CITY OF DULUTH

STAFF REPORT

File Number	PL 14-096	Contact	Jenn Reed Moses, jmoses@duluthmn.gov	
Application Type	Planning Review	Planning Commission Date	August 12, 2014	
Deadline for Action	Application Date	July 16, 2014	60 Days	September 14, 2014
	Date Extension Letter Mailed	July 21, 2014	120 Days	November 13, 2014
Location of Subject	2120 London Road			
Applicant	London Acquisitions	Contact	Abbot Apter, aapter@mercuryinv.com	
Agent	Dave Chmielewski	Contact	dave@blackhoof.com, 218-384-9727	
Legal Description	PID 010-1460-00960			
Site Visit Date	N/A	Sign Notice Date	July 29, 2014	
Neighbor Letter Date	July 22, 2014	Number of Letters Sent	30

Applicant is proposing a 2,558 sq ft Caribou Coffee and a 2,860 sq ft Burger King with 47 parking spaces.

DRAWING TITLE: PARKING STALLS & ISLANDS

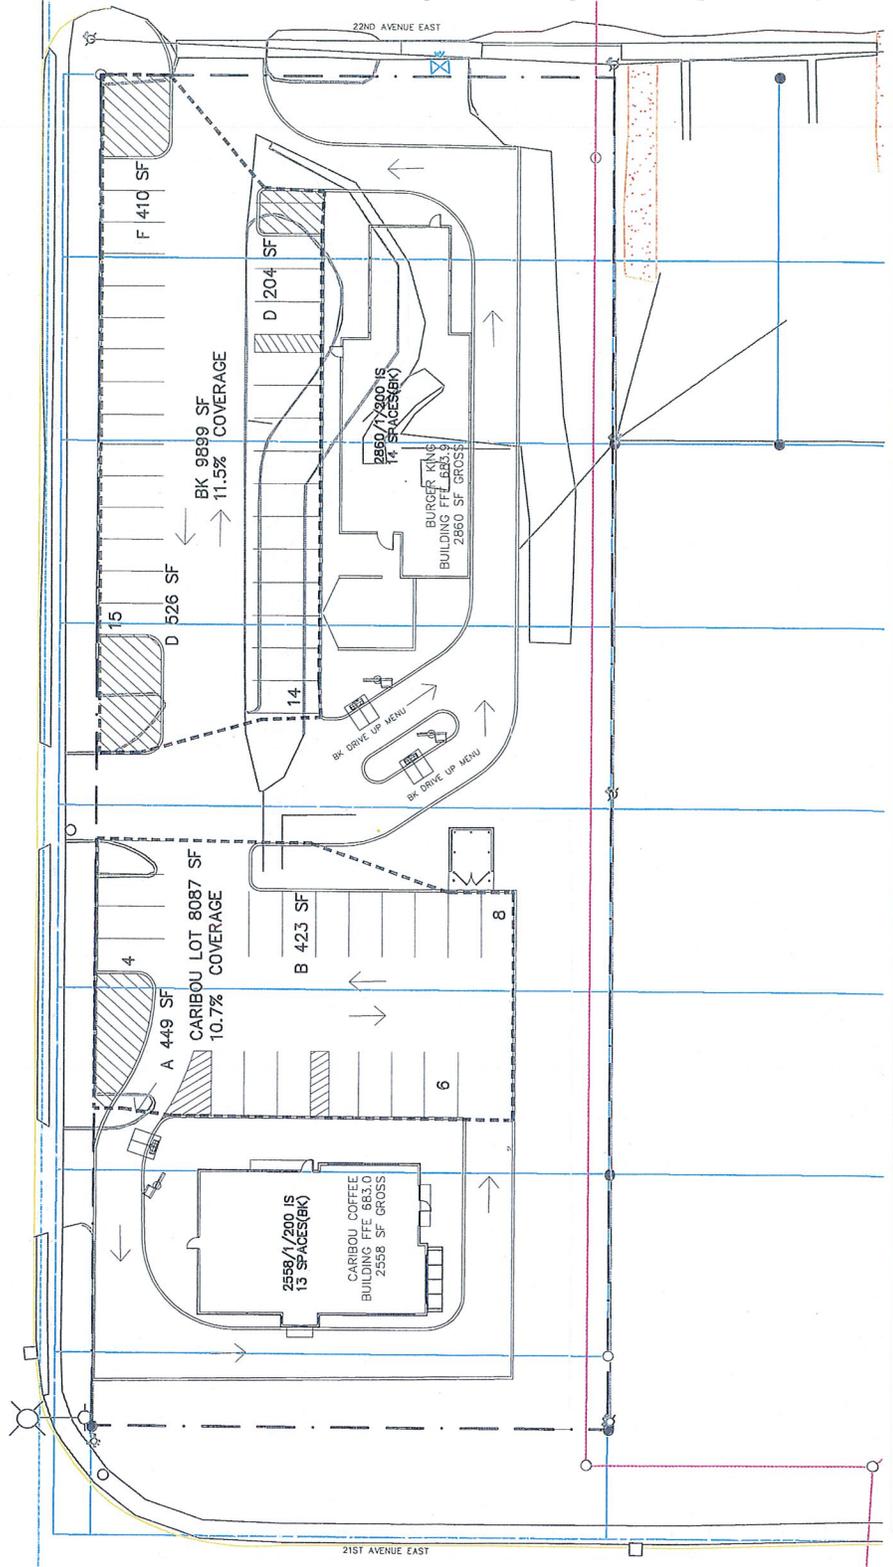
- 4.) 50-24 (Parking) - This site is required to have a minimum of 27 parking spaces, with a maximum of 41. Current site plan shows 47 parking spaces. At least 50% of the parking is behind the front facade on London Road.

- 3.) Project shall remove 6 parking spaces to comply with maximum parking requirements, or received a variance.
- 4.) Landscaping plan shall be revised to provide 15% interior parking lot landscaping and all required street frontage landscaping.

VISIONAIRE LIGHTING
PHOTOMETRIC STUDY #
P820044181E100 LONDON-04
TSR Lighting
08/01/14

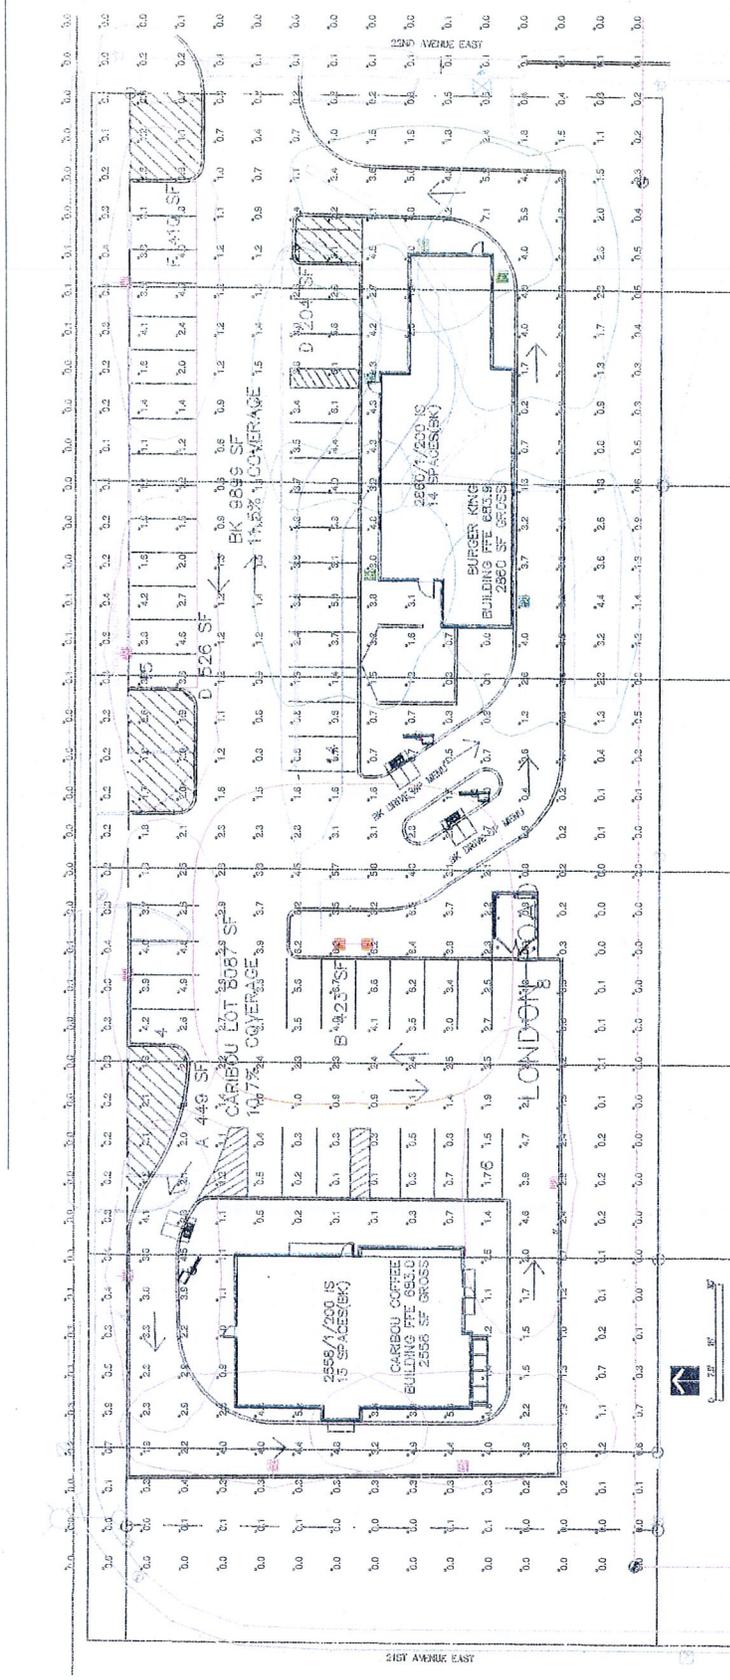
- 9.) 50-30 (Building Design Standards) - Size of this development does not trigger building design standards.
- 10.) 50-31 (Exterior Lighting) - Applicant submitted two potential photometric plans for the site. Both exceed allowable light levels.

- 5.) Screening of mechanical equipment and dumpsters shall be confirmed prior to receiving a building permit.
- 6.) All lighting shall comply with UDC requirements.
